Subject: CERTIFICATE OF COMPLIANCE NO. 9292 FOR THE MODEL NO. PATRIOT PACKAGE: Follow-up Information Requested during Conference Call Held June 2, 2005 - DOCKET No. 71-9292; TAC No. L23770

Enclosure 1: Response to Follow-up Questions

Application for Certificate of Compliance for the Patriot BWR Fuel Shipping Package

NRC Certificate of Compliance
USA/9292/AF-85
Docket 71-9292

Figure 1 USLs for 49 LWR-type fuel critical experiments, k_{eff} vs AEF (0.0 – 0.5 eV)

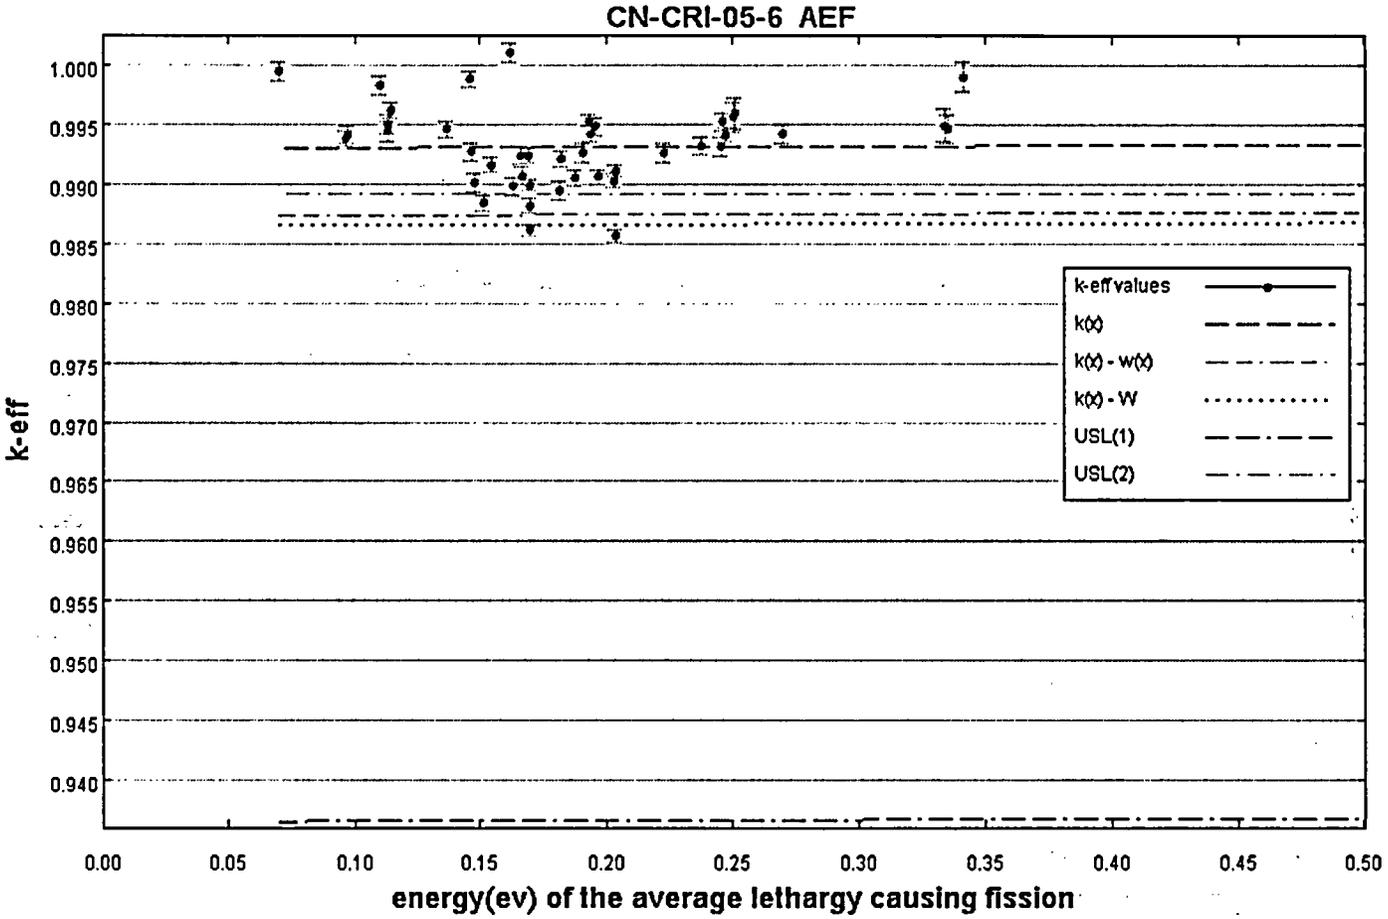
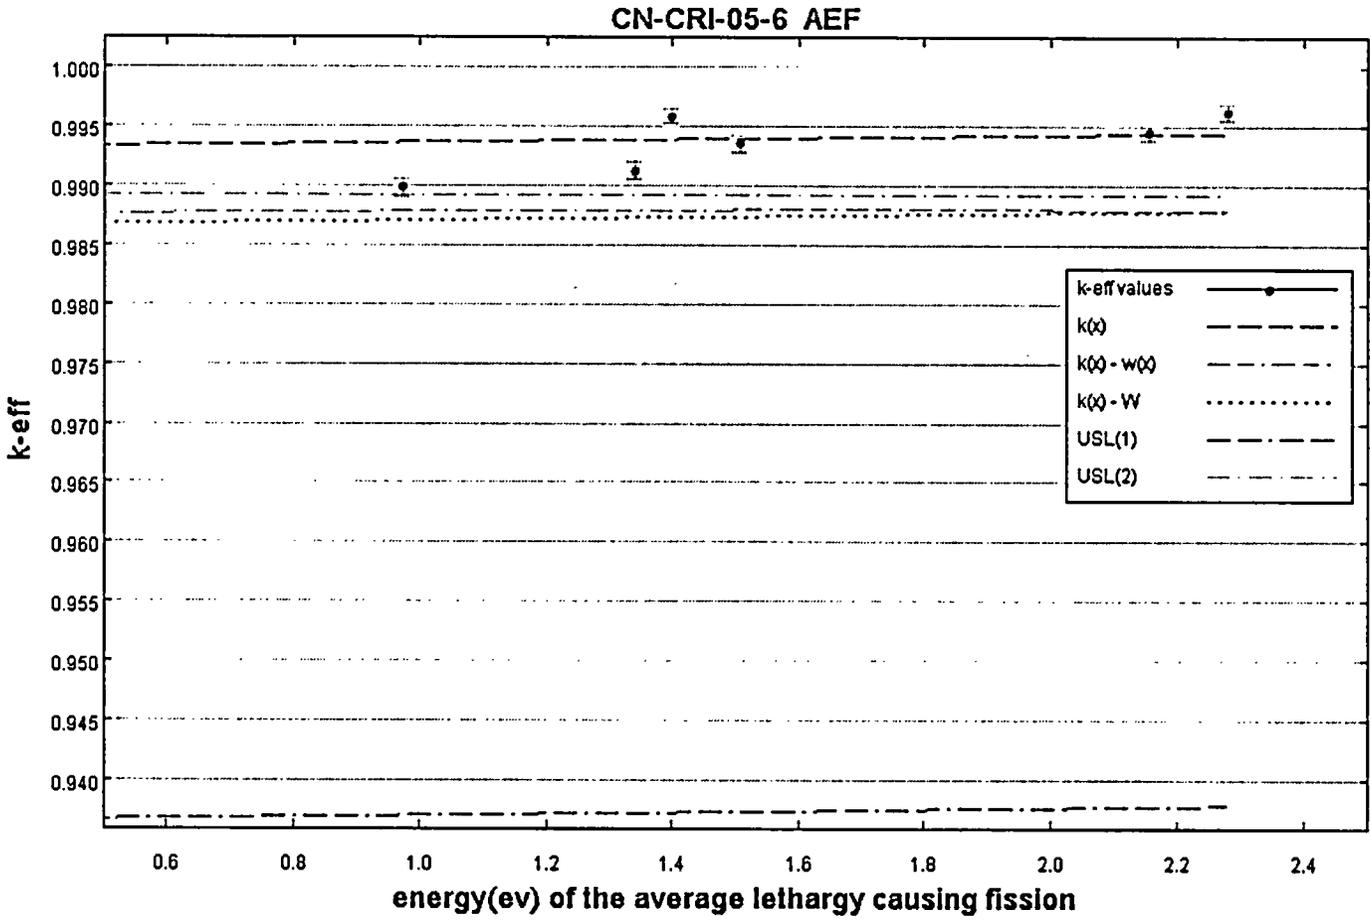
On page 6 of 13 in our RAI response (NMS-NRC-05-005) Westinghouse states,

“The energy (ev) of the average lethargy causing fission for the PATRIOT package that results in a maximum k_{eff} over the range of interspersed moderation densities and moderator configurations is approximately 0.6 ev. Only six of the critical benchmark critical experiments have EALF that is greater than 0.5 ev, but the *results show no significant trend in bias vs. energy. The largest bias results from a the correlation to the enrichment parameter*, and results in an upper safety limit of 0.9343 including a 0.05 arbitrary margin to ensure subcriticality.”

Provide trend data to substantiate these statements.

The USLSTATS output for AEF and ENR are provided to address the items above. Further, the data are graphed as follows:

- USLs for 49 LWR-type fuel critical experiments, k_{eff} vs AEF (0.0 – 0.5 eV),
- USLs for 49 LWR-type fuel critical experiments, k_{eff} vs AEF (0.5 - 2.5 ev), and
- USLs for 49 LWR-type fuel critical experiments, k_{eff} vs enrichment
